RATHGEBER NATURAL RESOURCE PARK

Trail Study Presentation

Recommendations: Northern Trail System

Double L Ranch Development: Area of Study/Recommendations

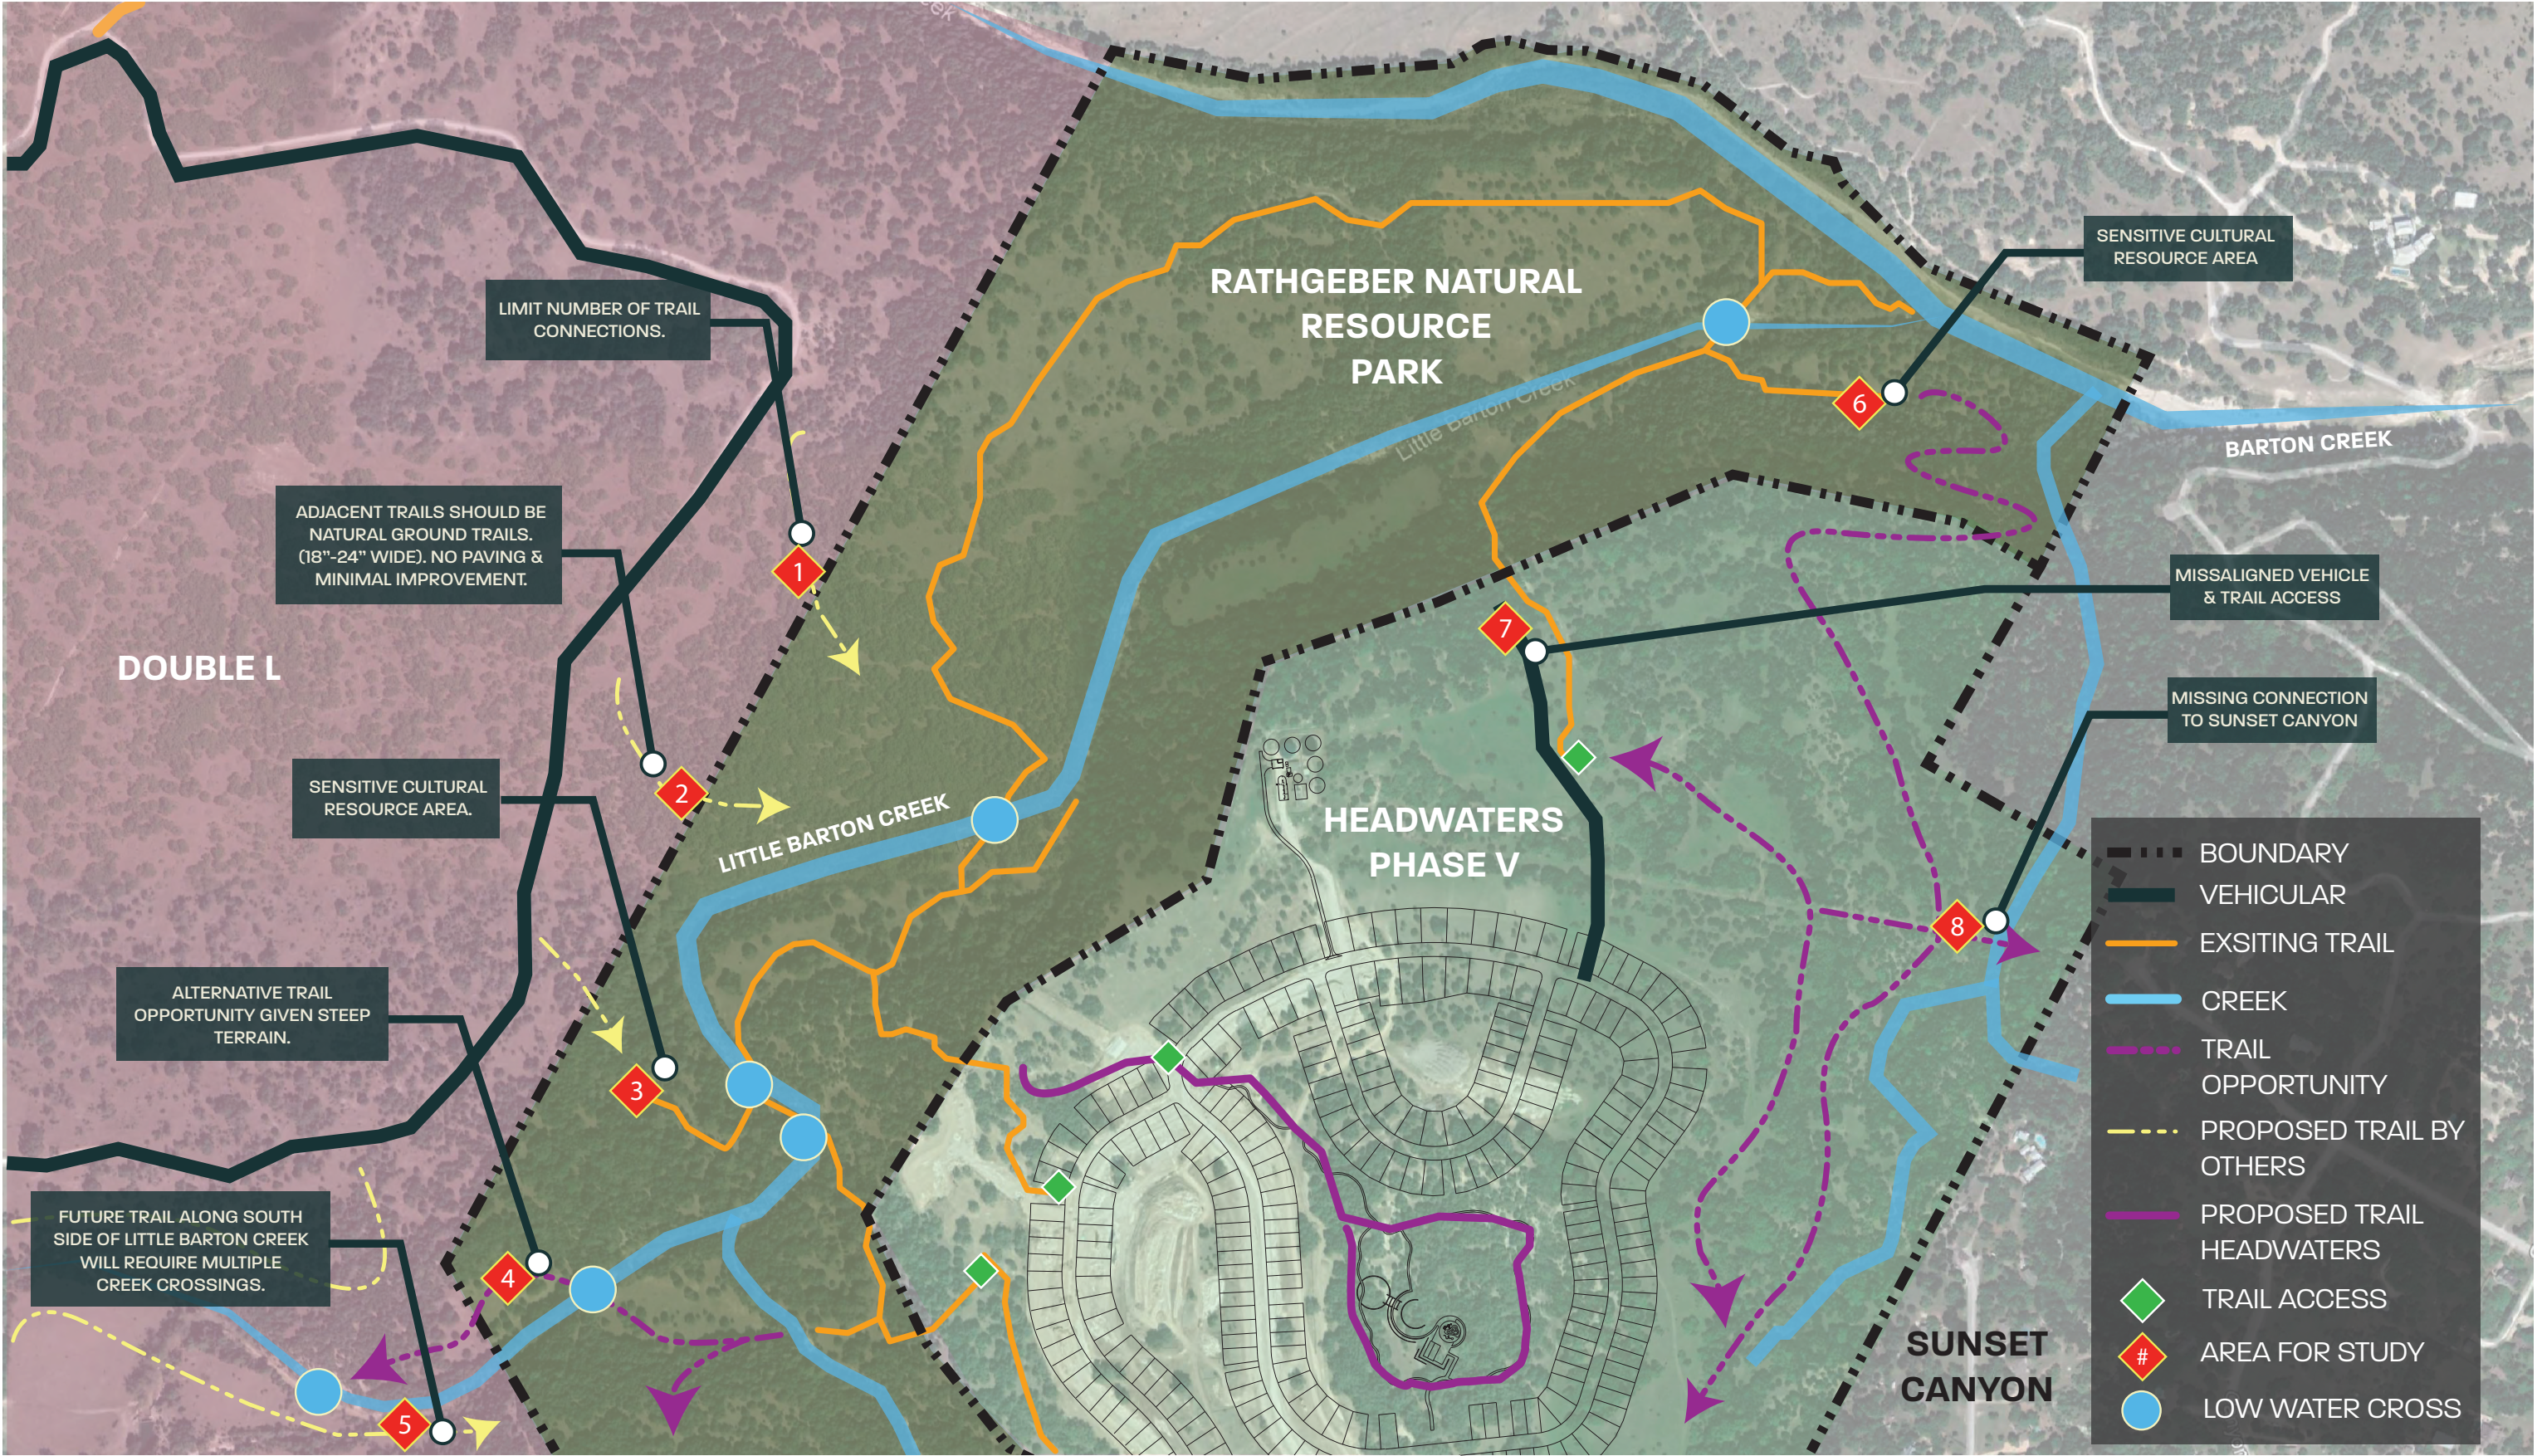
- 1. Trail connections from future “Double L” development leading into Rathgeber park should be limited to preserve wilderness experience within the park. These proposed trails also connect to parts of Rathgeber that lack an existing trail.
- 2. Any adjacent trails connecting to Rathgeber Park should be rustic/natural ground trails that require no paving and minimal changes. (18”-24” wide).
- 3. Sensitive cultural resource sites should be protected or left undisturbed by trail system.
- 4/5. An alternative (long distance) trail should be explored north of “Little Barton Creek” due to the steep terrain on the south side. In any case, this trail along “Little Barton Creek” will require multiple creek crossings as the cliffs prevent passage solely on one side of the creek.

- 6. The existing sensitive cultural resource site should be protected here. (Discussion over this site needed for full context.)

- 7. A vehicular road was cleared to the tree line (as depicted in Headwaters Masterplan - “Easement”) and does not align with the existing trails entering into Rathgeber Park.
- 8. There could be a potential trail opportunity along eastern boundary of the Headwaters development with a pedestrian connection into Sunset Canyon.

Headwaters: Area of Study/Recommendations

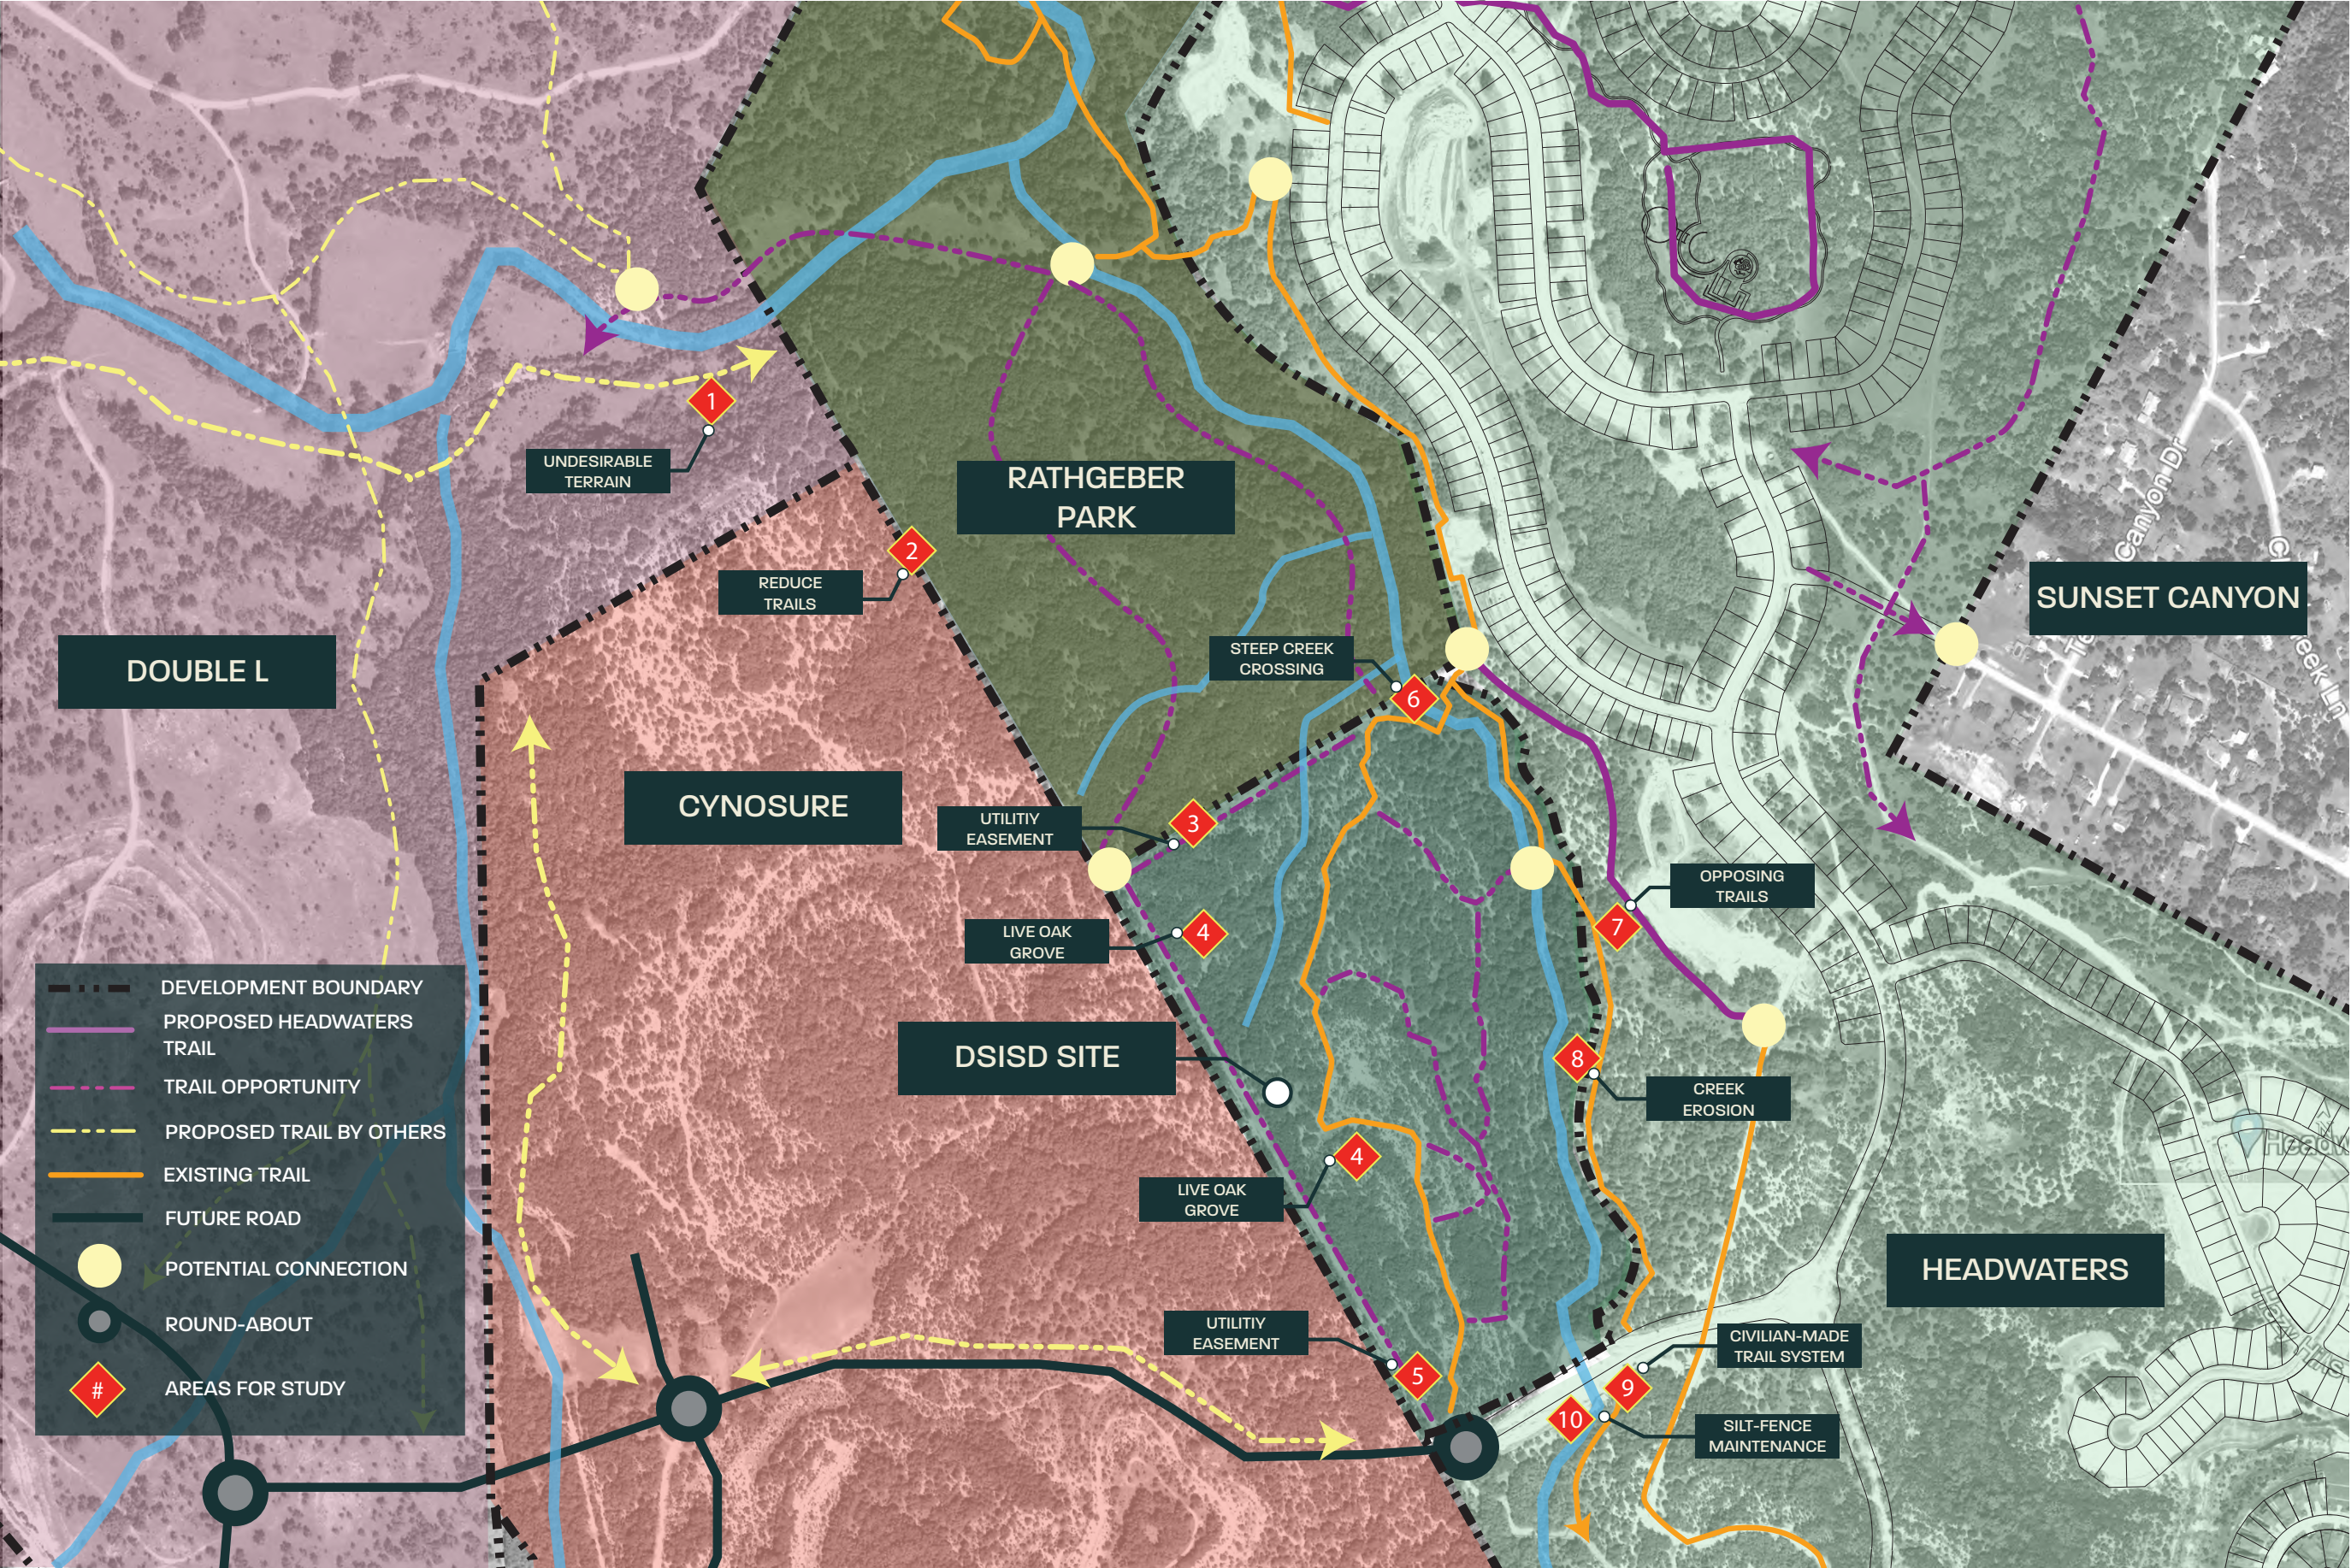
7.

An existng mountain bike trail designed by civilians directly opposes the proposed North-South trail planned on Headwaters. We recommend that the existing pedestrian trial be explored as a suitable alternative, as it is well-marked and provides close proximity to the creek.
8.

There is evidence of severe erosion along the creek that should be addressed if a pedestrian trail will be located near-by.
9.

The exising mountain bike trail continues further south into the Headwaters development and should be explored as an option to be included into the official trail system.
- 10

Disturbance from rapid development has caused intense erosion and siltation along the creek. Silt fences should be properly investigated and maintained.
